## DEVELOPMENT APPLICATION ASSESSMENT REPORT

Application Number:	DA2022/1985
---------------------	-------------

Responsible Officer:	Maxwell Duncan
Land to be developed (Address):	Lot A DP 412396, 27 Waine Street FRESHWATER NSW 2096
Proposed Development:	Demolition works and construction of a residential flat building.
Zoning:	Warringah LEP2011 - Land zoned R3 Medium Density Residential
Development Permissible:	Yes
Existing Use Rights:	No
Consent Authority:	Northern Beaches Council
Delegation Level:	NBLPP
Land and Environment Court Action:	No
Owner:	Pyco At Greenslopes Pty Ltd
Applicant:	Pyco At Greenslopes Pty Ltd

**Figure 1 - Building Height calculation - Section A**

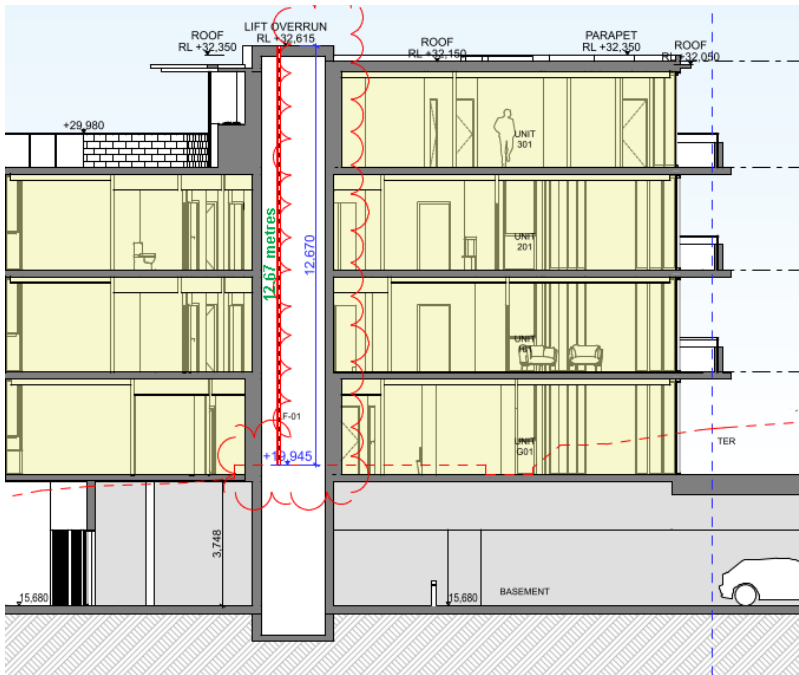
The application proposed a maximum height of 12.67 metres, representing of a 15.1% departure from the 11 metres maximum building control. The proposed development is not supported and recommended for refusal due to the non-compliance with the built form controls and resulting scale of the building. The matter of non-compliance with the Height of Buildings Development Standard is addressed in detail elsewhere in this report (refer to Clause 4.6 Exceptions to Development Standards under the WLEP 2011 section of this report).

Development standard:	Height of buildings
Requirement:	11m
Proposed:	11.05m - 12.67m
Percentage variation to requirement:	up to 15.1%

**Figure 3 - Envelope non-compliance eastern facade**

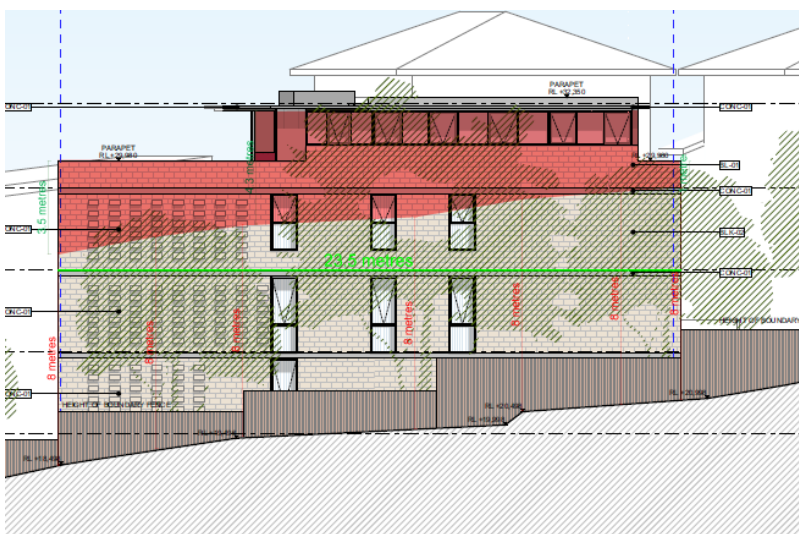
The proposal sits outside of the building envelope on the eastern facade as depicted in figure 3 below. The eastern facade obtains an encroachment ranging from 1 metre to 4.3 metres in vertical height for a horizontal length of 23.5 metres, resulting in a variation between 20-86%.

The application has a number of non-compliance's with the prescribed controls including building height under the WLEP 2011, number of stories, non-compliance with landscape open space. These non-compliances, coupled with the non-compliance with the building envelope point towards a development that has an excessive building height and scale, as well as visual bulk exceeds than anticipated by the planning controls.
